HERITAGE IMPACT STATEMENT

166 Pittwater Rd, Manly NSW

July 2022

Issue C: 6.12. 2022

Drawing DA//05 Plan of the Existing entry level/Ground floor.

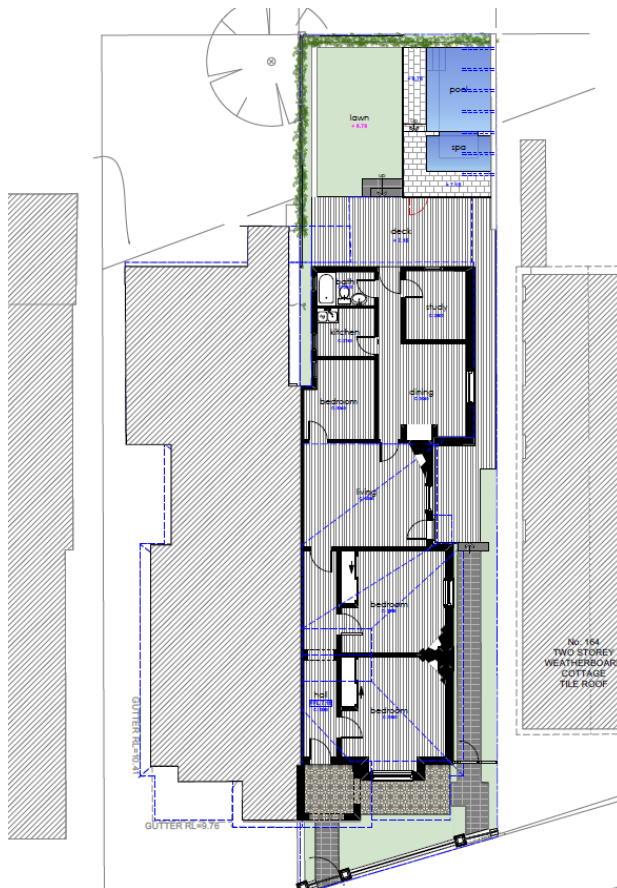
Drawings DA05 & 06 do not illustrate the existing rear of the building with remnant brick wall to north side of deck and do not show the existing storage unit to the front southern side of the building

- Demolish the rear external eastern wall to the deck
 - The existing brick wall to the northern end of the deck is not indicated on the existing or proposed plans. Despite it being a minor element, it is clearly original material and forms part of the dwelling as is indicated by the adjoining similar semi-detached house and is capable of retention as part of the existing/proposed barbecue

- Following the modification, the level of demolition has been substantially reduced with the living and dining rooms capable of interpretation
 - The existing & proposed ground floor plans and East Elevation should be corrected to indicate retention of the original northern brick wall bounding the retained/replaced barbecue as this element is external and interprets the original part of the pair of semi-detached houses

DA/06 Proposed Entry/Ground floor plan

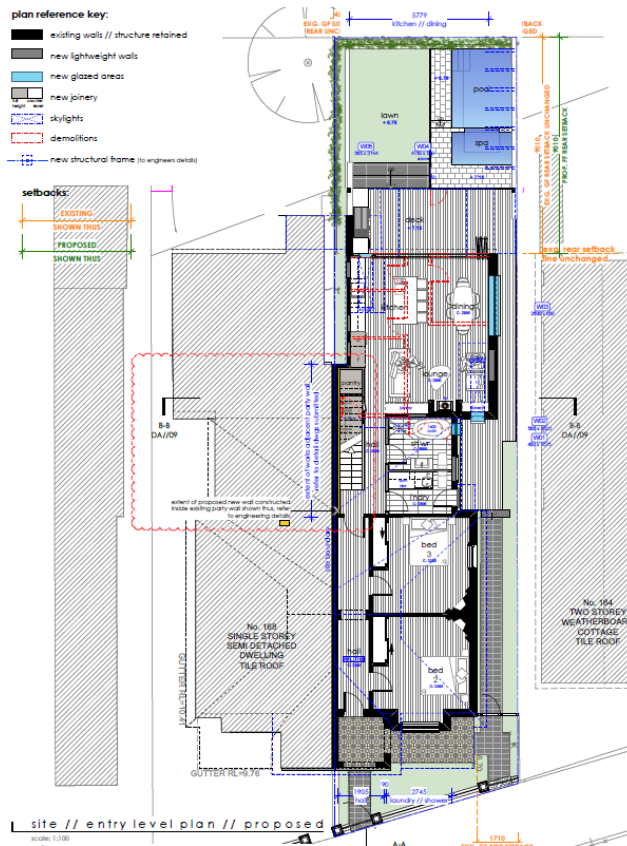
Drawing DA06 illustrates the extent of the demolition work proposed

- Demolish the fireplace in the living room and doors to the rear of the house and third bedroom
 - The revised Floor plan indicates retention of the fireplace in the Lounge Room and retention of the door to the third bedroom while the original door from the Living room into the dining room is infilled to accommodate the bathroom and Lounge room joinery. The original opening is however capable of interpretation within the finishes.

- Demolish the fireplace to the dining room and wall defining the third bedroom
 - The revised Floor plan shows retention of the fireplace to the dining room. While door to the rear of the original house is removed for access next to the proposed stair, this can be interpreted with a bulkhead

- Demolish the windows to the third bedroom, kitchen and bathroom on the north elevation
 - The revised drawings DA//06 and 10 indicate that these original windows are to be infilled to accommodate the new kitchen. This intent is taken from the plan as the Elevation DA//10 does not show these original external features as they are largely concealed from view by their location as part of the nature of the light well and adjoining semi-detached property. The three windows are capable of interpretation within the infill detailing.
